SUBDIVISION COMMITTEE
METROPOLITAN AREA PLANNING COMMISSION

STAFF REPORT
(Final Plat; Preliminary Plat Approved 7/27/89)

CASE NUMBER: S/D 89-48 - WINDEMERE SECOND ADDITION

VICINITY MAP:

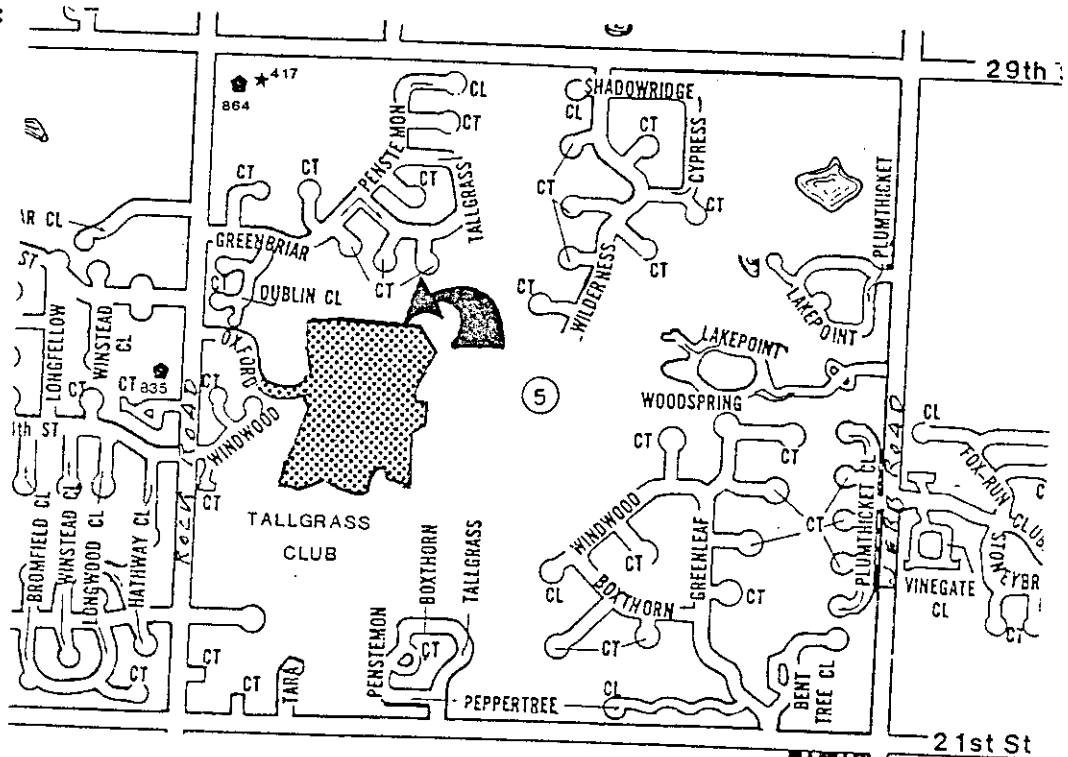
- NOTE: This plat is a part of the Tallgrass Community Unit Plan (DP-96); specifically, parcels 9 and 10. Though Oxford is presently platted as a private street this plat intends to replat Oxford as a public street.

- A. The applicant shall either abandon or amend the existing petitions on file for this property. If projects are to be abandoned as a result of this replat, the applicant shall pay off the charges against the abandoned projects. Square footage figures shall be provided for the lots within this plat so existing special assessments and petitions may be amended.

- B. The applicant shall guarantee a traffic signal at the intersection of Rock Road and Oxford. The guarantee will be held until traffic conditions warrant, as indicated by the Manual on Uniform Traffic Control Devices, the installation of such signalization.

- C. The applicant shall guarantee a left turn bay, for south bound traffic on Rock Road, at Oxford Circle.
 - D. The applicant shall guarantee ramp or rollback curb on Oxford (Circle) between holes 7 and 8 as is required by Provision "16" of DP-96.

- E. The applicant shall guarantee the extension of sanitary sewer to serve the lots being platted.
 - F. The applicant shall guarantee the extension of City water to serve the lots being platted.

- G. The applicant shall guarantee any drainage improvements required by the platting of this property.
 - H. The applicant shall guarantee construction of the storm sewers required by this plat.

- I. The applicant shall guarantee the paving of Oxford Circle. This paving petition shall include construction of a sidewalk on one side of this street and, if necessary, bring that portion of Oxford Circle already existing to public standards.

- M. Since this plat proposes the platting of narrow street rights-of-way, which requires the platting of "15-foot public drainage, utility and private street easement," a restrictive covenant shall be submitted which calls out restrictions for lot-owner use of these easements. Retaining walls and change of grade shall be prohibited within these easements as well as fences, earth berms and mass plantings. Any planting within this easement shall be reviewed by the City Forestry Division prior to installation.

- N. The applicant shall submit a copy of the instrument which establishes the K.G.& E. easement on this property.
- O. The applicant shall provide proof, by letter from the K.G.& E. or by copy of the easement agreement, that the dedication of street right-of-way over a portion of the easement and the use of part of this easement as a general utility easement are acceptable.

- P. Since the KANEB Pipeline easement abuts this plat along its north line, the final plat shall show the recording information for the pipeline.
- Q. The applicant shall provide proof, by letter from the pipeline company or by copy of the pipeline easement agreements, that the pipeline easement as shown is sufficient and that utilities may be located adjacent to and within the easement.

- T. This plat will require a waiver of the C.U.P. requirement (provision 18) that fire lane easements connect all parcels. It is the applicants intent not to connect parcels 8 and 9 as is shown on the C.U.P.
